LEA ACP clarification questions

This note provides answers to clarification questions that have been received regarding the Leeds East Airport (LEA) Airspace Change Proposal (ACP). It is to help clarify the proposed change and the consultation process as a result of any questions that we have received. It does not contain the consultation responses.

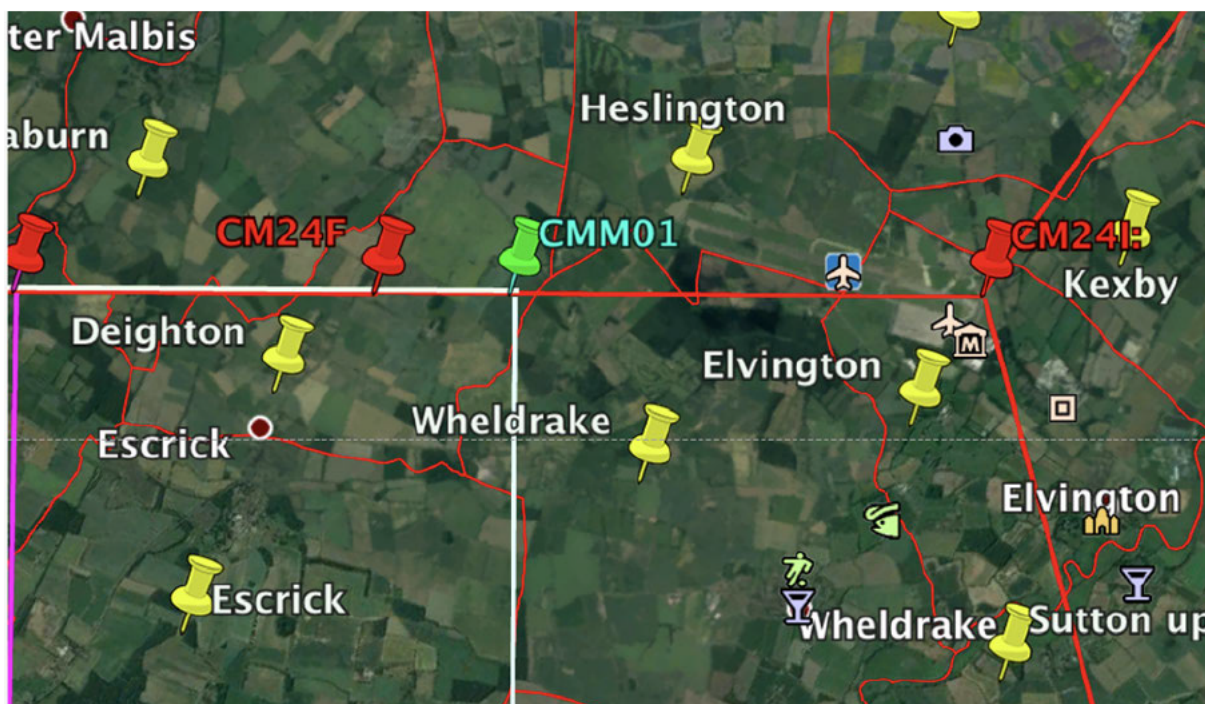
- 1) My question is could a similar request not to overfly Deighton or Crockey Hill villages be included in the approach instructions for Leeds East please.

The RNP procedures are fixed tracks over the ground and the pilots should not deviate from them.

The track passes to the NW of Deighton. The procedures use GPS and are flown very accurately, hence they would not be expected to fly over the village

The Final Approach Fix CM24F is shown below.

At this late stage of the approach aircraft will be fully established and lateral deviation from the track is very unlikely.
